22nd June 2022

Re. PA/05084/21 - Garden of Eden, Triq il-Barrieri, Zurrieq

To close existing openings facing part of road and propose 2 new openings, 1 of which to serve for vehicle access.

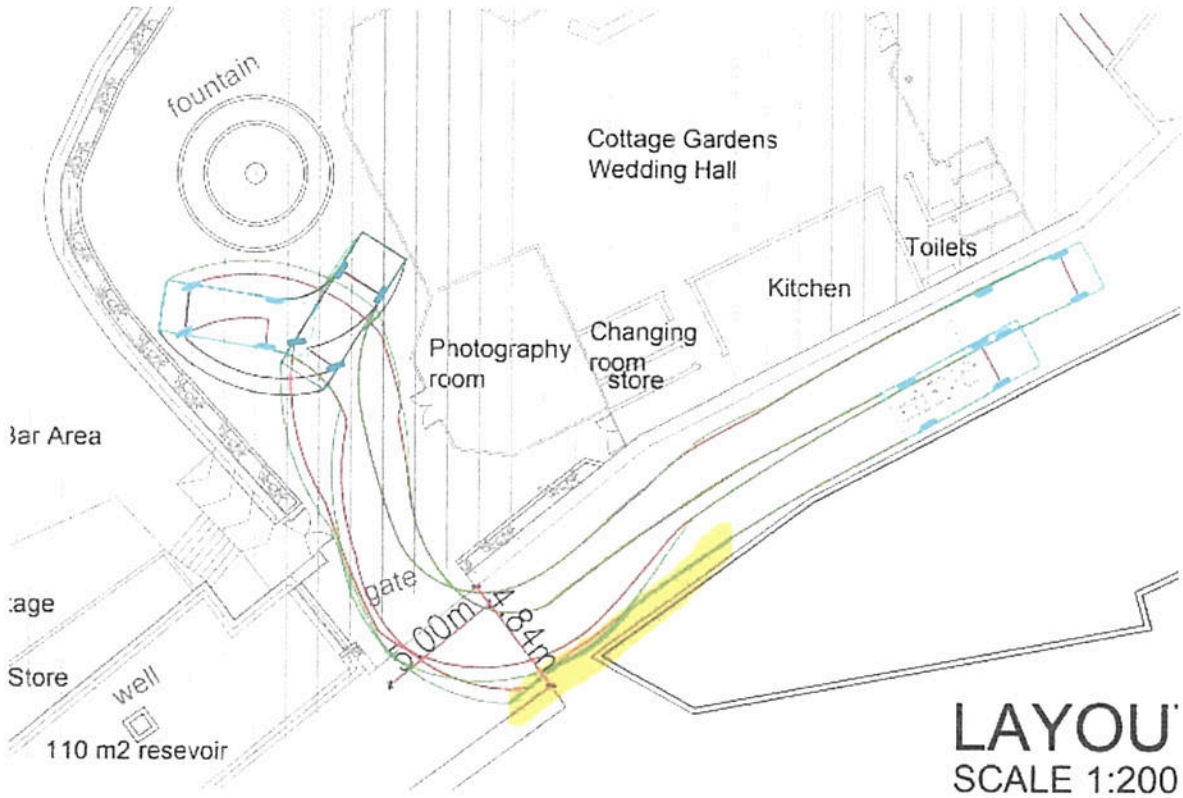
- 1. The Board also failed to take into consideration the numerous illegalities which the proposed opening will lead to. The Board simply assessed the application on the boundary wall, and did not take the site in question in its entirety.

It is obvious that the opening of a door in the boundary wall is done to inevitably lead to the structures present beyond the boundary wall in question. The application therefore does not simply concern the wall but must be assessed in virtue of the site in its entirety.

The application cannot be assessed as a stand alone boundary wall. The wall is part of a site and all apertures in it grant the access to the same site. Having a piecemeal application limited to only a wall is abusive and will set a dangerous precedent of avoidance of responsibility on irregularities in applications.
